GETCO	ENGG. CELL
DRAWING APPROVAL	
☒	Cat-1 Approved <u>N.M. Singh</u>
☐	Cat-2 Approved with comments _____
☐	Cat-3 Approved for information _____
☐	Cat-4 Not Approved _____

PART LAYOUT PLAN FOR 2 Nos. 400KV CHARAL LINE 1 & 2 BAYS ,
400/220KV ICT -4 BAY (HV SIDE) & LV SIDE AT EXL. 220KV TORRENT-1 ,
EXL. 220KV TORRENT-1 BAY IS TO BE SHIFTED AT EXL. 220KV TORRENT-2 BAY,
EXL. 220KV TORRENT-2 BAY IS TO BE SHIFTED AT NEW PROP. LINE BAY

**PART LAYOUT PLAN OF
400KV SOJA SUB-STATION**

<u>DRAWN:</u>	<u>CHECKED:</u>	<u>APPD:</u>		
DE (ENGG.)	EE (CIVIL)	EE (ENGG.)		<u>SIZE:</u> A0
<u>SCALE:</u>	<u>DATE:</u>	<u>DRG. NO:</u>	<u>SHEET:</u>	<u>REV:</u>
N.T.S.	17.07.2026	GETCO / E / 4S-152 / P-004	1 OF 1	R-11(A)

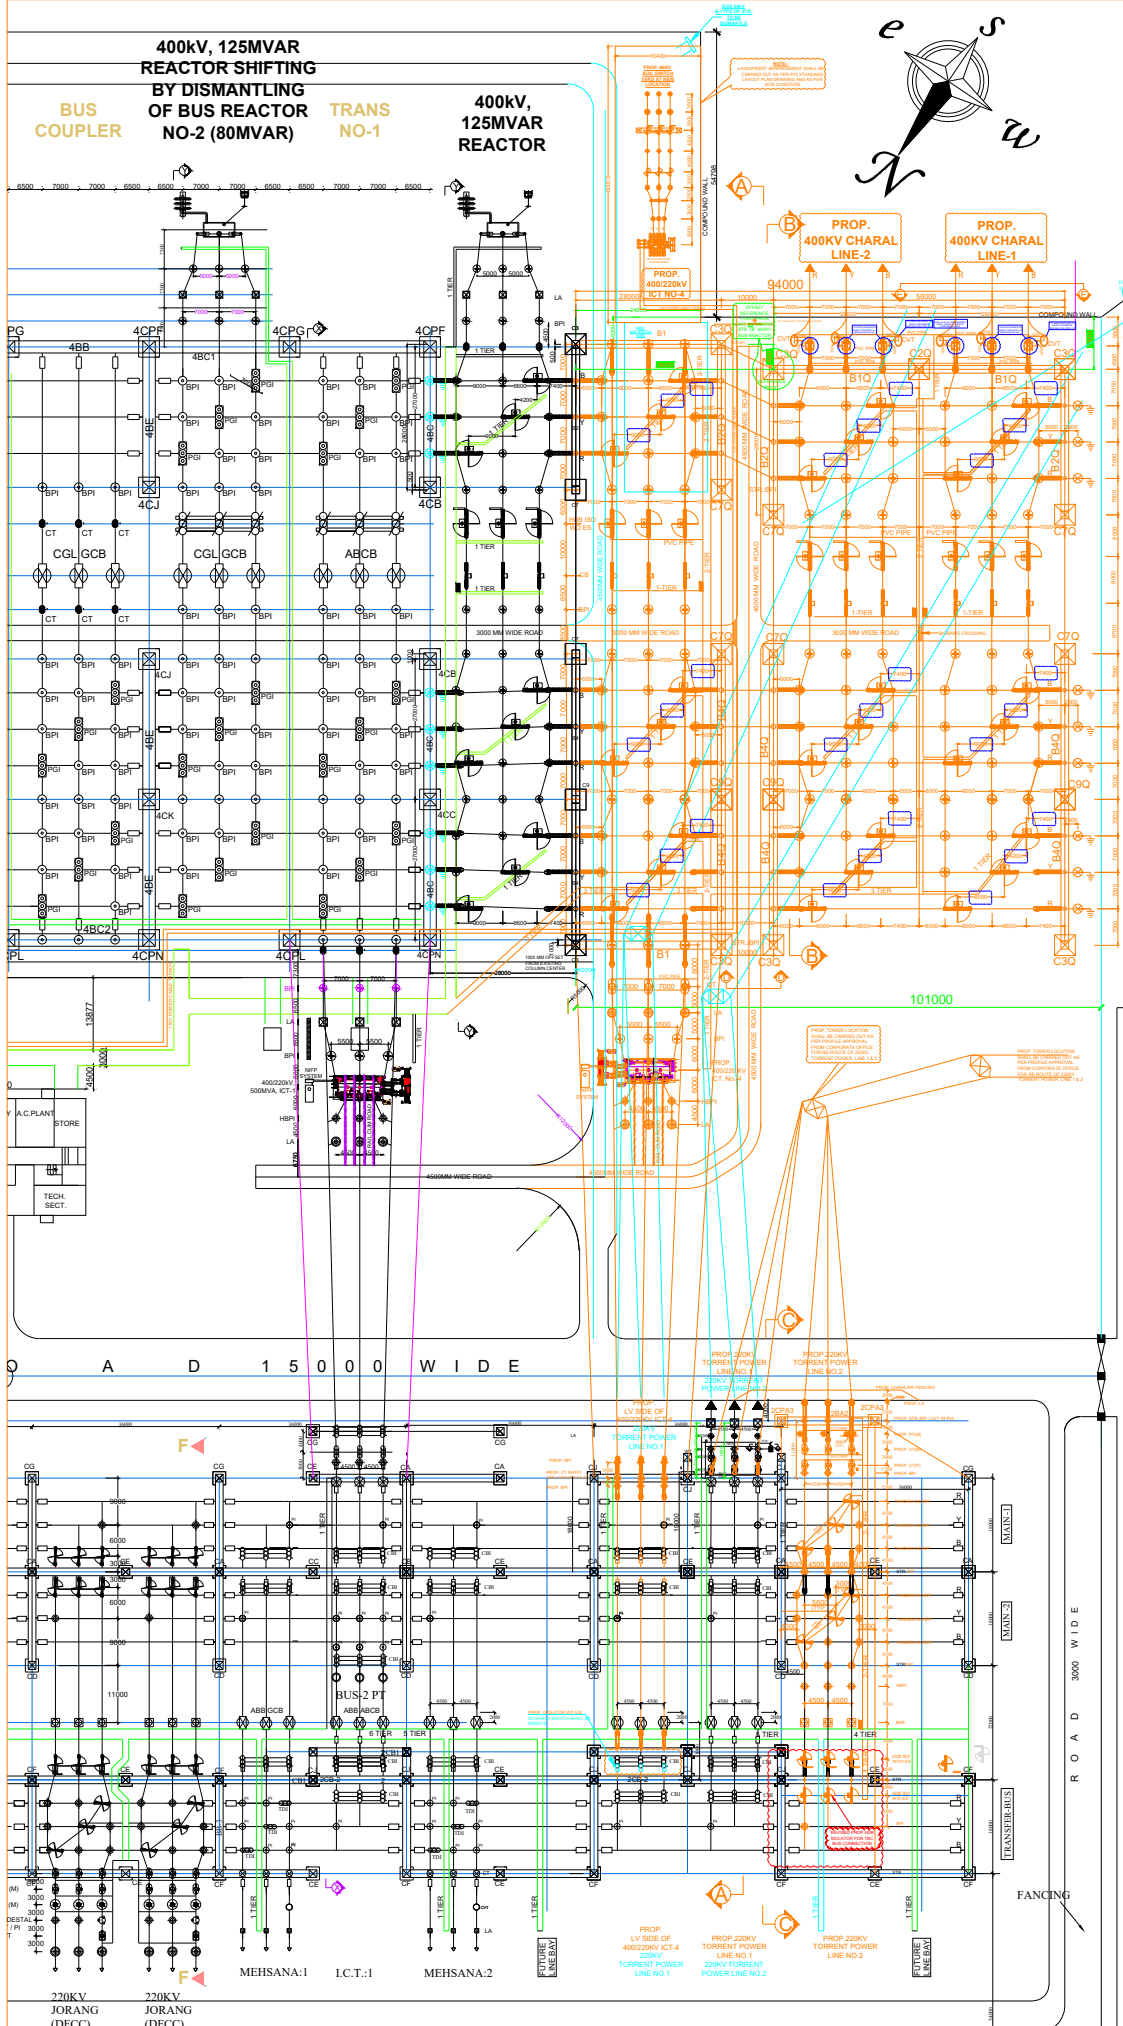
1) TO CHANGES DIMENSION AT 40KV+ TANDAM ISOLATOR LA AND CVT LOCATION FOR 40KV+ CHARAL LINE & 6 LANE BAYS
17.07.26	R-11(A)		2) TO CHANGES DIMENSION AT 40KV+ TANDAM ISOLATOR AT PROP. 400V/220KV IC-T4 BAY.
			NOW R-11 REVISION TOTAL OFSE ARE EARLIER R-10 REVISION SCOPES & TO ADDITION OF 2 NOS. 22KV LINERS FOR LOLO OF 220 KV JAMLA-GANDHINAGAR-1, SO TOTAL R-11 REVISION OFSE AS UNDER

1) PROP. 2 NOS. 40KV CHARAL LINE 1 & 2 BAYS ARE ADDED UNDER GEC PASELI WITH BUS EXTENSION & ACCOMMODATION BY DISMANTLING OF EXISTING 22KV TOWER & REROUTING OF NEW 22KV TOWERS AS PER PROPOSED WORKS AS FOLLOWS PROPOSED SCHEMATIC DIAGRAM FOR 40KV+ TANDAM ISOLATOR POWER LINE NO.1 & 2

2) PROP. EHV AUGMENTATION OF NEW 4TH /40/220KV, 500MVA ICT BAY IS ADDED JOINING TO EXISTING 40KV+ REACTOR BAY AND LV SIDE (22KV) SIDE BAY IS ACCOMMODATION BY SHIFTING OF EXISTING EXISTING 22KV TORRENT POWER LINE -1 AND NECESSARY MODIFICATION REQUIRED STRENGTHENING BY TWIN 3X9 COND AT JUMPERS, DROPPERS & FLYOVER BUS

21.06.28	R11		3) EXISTING 22KV TORRENT POWER LINE -1 IS BE TO BE SHIFED AT ADJACENT BAY OF EXISTING 22KV TORRENT POWER LINE -2 LOCATION & EXISTING 22KV TORRENT POWER LINE -2 LOCATION IS TO BE SHIFT AT PROP+NEW 22KV BAY IN EXISTING 22KV BAY ARRANGEMENT & TO BE UPLIFTED EXISTING DISMANTLE EQUIPMENTS OF CT(PTOTECTION), CT (METERING), PT (METERING), CVT, LA FROM 20KV TORRENT LINE -1 LOCATION.

4) EXISTING 66K1 ALVADURY SWITCH FORMER BAY, 40KV+BUS EARTH SWITCH SHALL BE DISMANTLE & SHIFED AT NEW LOCATION AND TO DISMANTLE EXISTING 22KV TOWER FOR PROPOSED SCOPES OF WORK AS FOLLOWS 5) PROP. 2 NOS 22KV LINE BAYS ARE ADDED AT OPEN SPACE AVAILABLE IN EXISTING 22KV BAY ARRANGEMENT IN BETWEEN BAY OF LV OF 400/220KV IC-T3 & 22KV JAMILA LINE -2 FOR LOLO OF 220KV JAMLA-GANDHINAGAR-1
